Access Compliance Report

Public Rights-of-Way

(Curb Ramps)

Intersection ID: 48474	Main Street: AUTUMN_OAK_DR	Cross Street: WONDERING_OAK_LN	Location: NW
ADA ID: 6641B9DA1059	Ramp Type: PerpDiag	Initial Pass/Fail: Fail	Overall Compliance: No
Codes/Mitigation Info/Possible Solution			Severity Score: 35
			Field Measurements/Component Compliance

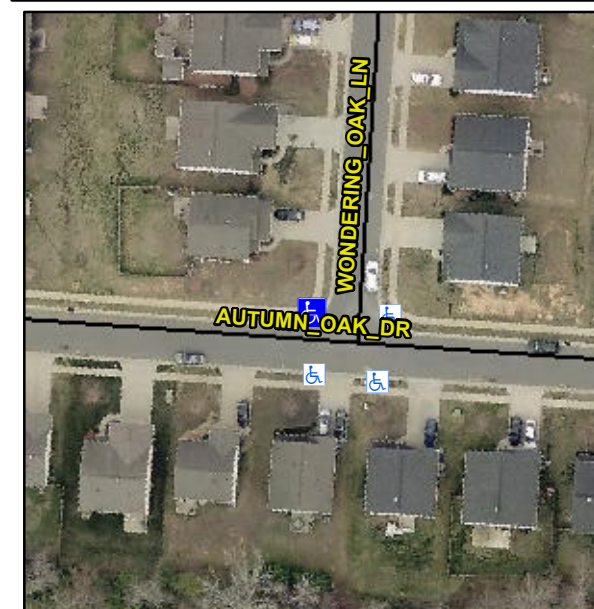
Not Found, R304.5.1, R304.2.2, R304.5.3

Compliance	Description	Data	Compliance	Description	Data
N/A	Ramp Length (in)	47.5	No	Ramp Slope (%)	14.8
No	Ramp Width (in)	46.5	No	Ramp XSlope (%)	4.5
N/A	Flare Type LT	N/A	N/A	Flare Type RT	N/A
N/A	Flare Slope LT (%)	N/A	N/A	Flare Slope RT (%)	N/A
N/A	Flare Traversable LT?	N/A	N/A	Flare Traversable RT?	N/A
N/A	Landing Length (in)	N/A	N/A	DWS Provided?	N/A
N/A	Landing Width (in)	N/A	N/A	DWS Contrast?	N/A
N/A	Landing Slope (%)	N/A	N/A	DWS Length (in)	N/A
N/A	Landing X Slope (%)	N/A	N/A	DWS Full Width?	N/A
N/A	Landing Curb? (Y/N)	N/A	N/A	DWS Offset (in)	N/A
N/A	Shared Landing?	N/A			
N/A	Gutter Ponding?	N/A	N/A	Gutter Slope (%)	N/A
N/A	Gutter Lip Ht (in)	N/A	N/A	Gutter X Slope (%)	N/A
N/A	Painted X Walk1?	No	N/A	Painted X Walk2?	No
	X Walk 1 Direction	To S		X Walk 2 Direction	To E
N/A	X Walk 1 Width (in)	N/A	N/A	X Walk 2 Width (in)	N/A
	X Walk 1 Slope (%)	0.2		X Walk 2 Slope (%)	2.8
	X Walk 1 X Slope (%)	2.5		X Walk 2 X Slope (%)	2.2

Remove & Replace Curb Ramp With Two New Directional Ramps or Equivalent.
